16 PUBLIC SUBMISSIONS

Re Fullerton Cove Sand Extraction Project MP07-0145

FULLERTON COVE SAND EXTRACTION PROJECT MP07 - 0145

Attachment A: Proposed and existing levels in relation to adjoining residence

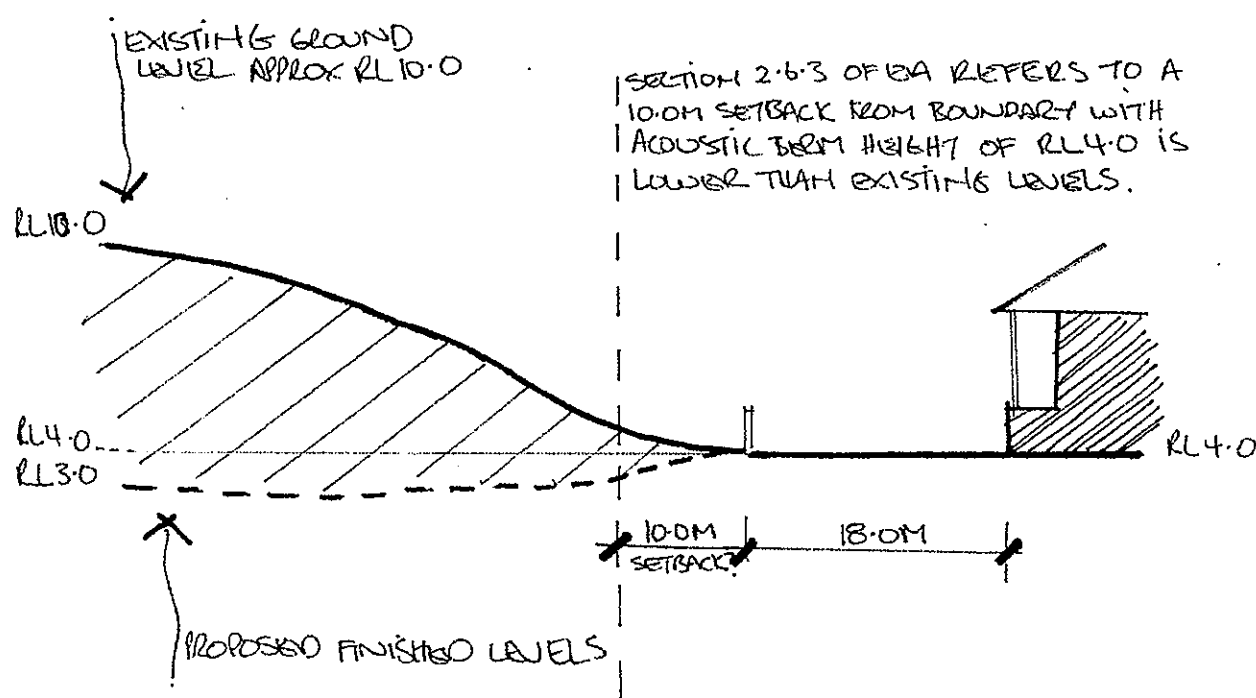
Furthermore, figures 2.1 and 2.4 of the EA indicate that the land adjoining our property will batter down, resulting in our property overlooking the development site. It should be noted that figure 2.1 *Previously Mined Area, Existing Landform and Proposed Extraction* area shows only the finished contours of the site, and does not indicate the extent of extraction and re-contouring that will occur along our property boundary. Please see Attachment A showing the existing and proposed levels in relation to our property and residence.
